Final Plat - Comment Response Letter

Citizen on Constitution  
El Paso County, Colorado

Prepared: October 26th, 2022

PCD File Number: SF-226

LANDSCAPE PLAN

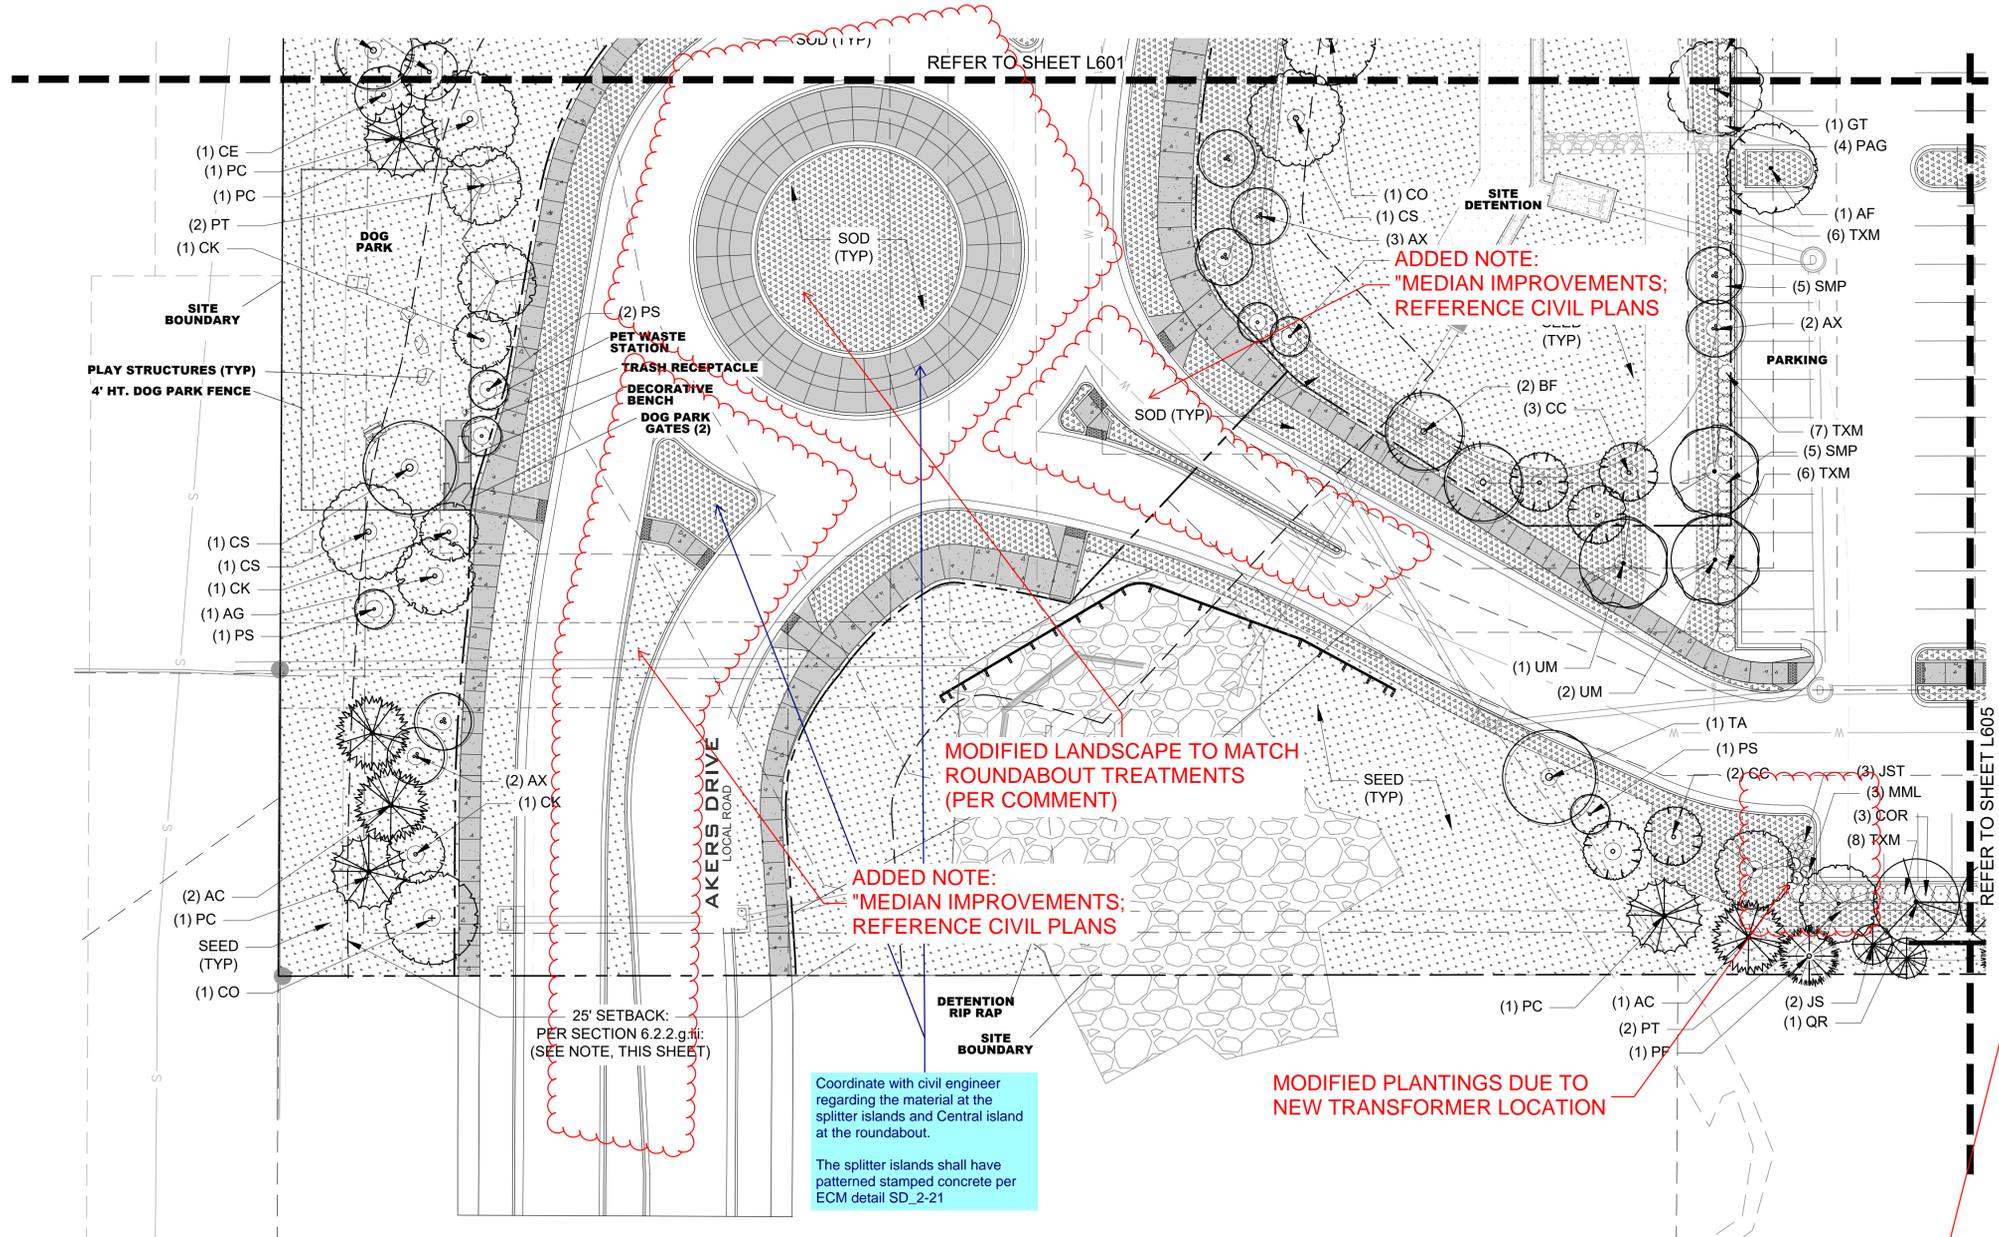
Provide landscape at the central island in lieu of the proposed stamped concrete/hardscape.

Per Wisconsin DOT (see excerpt) the center shall be raised a min. of 3.5 ft and max 6ft. (ground slope not to exceed 6:1). Please provide the proposed ground slope and landscaping at the central island. The intent as indicated in Wisconsin DOT 30.5.11 (see also (11-26-40) is to enhance driver recognition and limit the ability of the approaching driver to see through the other side.

MODIFIED LANDSCAPE TO MATCH  
ROUNDABOUT TREATMENTS  
(PER COMMENT)

ADDITIONAL PLANTINGS FOR  
ROUNDABOUT ENHANCEMENTS
